RE: Belvedere – REQUEST FOR VARIATION FROM ZMA-2004-007 Variation #53

RE: Belvedere – REQUEST FOR VARIATION FROM ZMA-2004-007 Variation #54

RE: Belvedere – REQUEST FOR VARIATION FROM ZMA-2004-007 Variation #55

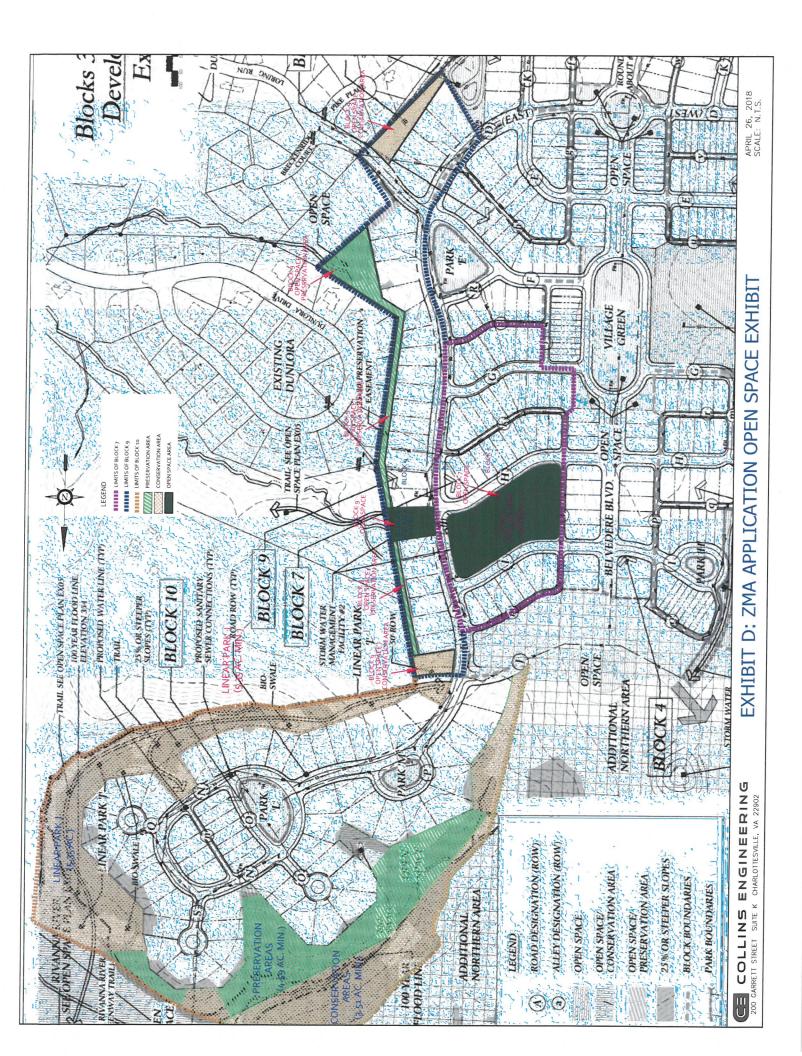
A variation is being proposed for the Belvedere project to update the open space areas within Block 9 and Block 10, as listed in Table 4 in the Belvedere Code of Development on page 15. With the approval of previous development plans, subdivision plats, and variations to the Code of Development and the Block IIB development, the provided Greenspace for Block 9 was modified and currently does not match the open space requirements in the approved Table 4 Green Tabulation Chart. Between the Open Space Block 9 requirements and the Block 9 Preservation Easement requirements, the changes to the overall Block 9 open space decreases the required conservation area by 0.68 acres, decreased the Preservation area by 0.57 acres, and increased the General Open Space area by 0.64 acres. As shown in the Exhibits D and E, the location of the open spaces developed and platted within Block 9 are consistent with the ZMA Application Open Space Exhibit, but the overall amount and type of open spaces have changed. The change in acreages are reflected in the attached Open Space Charts. The net open space change from the modifications is an overall open space deduction of 0.61 acres between the required open spaces within Block 9.

To compensate for the reduction of open space within Block 9 from the development plans, plats, and variations, the applicant is proposing to add additional conservation and preservation area to Block 10, as shown on Exhibit E & Exhibit F. The additional preservation and conservation added with the development of Block 10 will compensate for the loss of preservation and conservation within Block 9. Since some of the preservation and conservation areas were recorded as General Open Space within Block 9, the proposed changes will increase

the minimum overall dedicated Green Space areas from 83.88 acres to 84.1 acres. These are just the minimum required Green Space areas within the development. Based on the analysis of previously developed Blocks within Belvedere (as shown in the overall chart attached to this variation), additional Greenspace area above the minimum requirements have been created, platted, and/or dedicated, and in some blocks less Greenspace areas have been created, platted, and/or dedicated. With the proposed Greenspace modifications, there will be no change in the minimum amount of required dedicated Conservation area and Preservation area, and the minimum overall required Green Space area increases with this variation. This variation will also account for other Greenspace areas not fully platted and/or dedicated in some of the previous blocks that have been developed.

Note: The total Open Space Proposed is 40.1 % of the Total project area
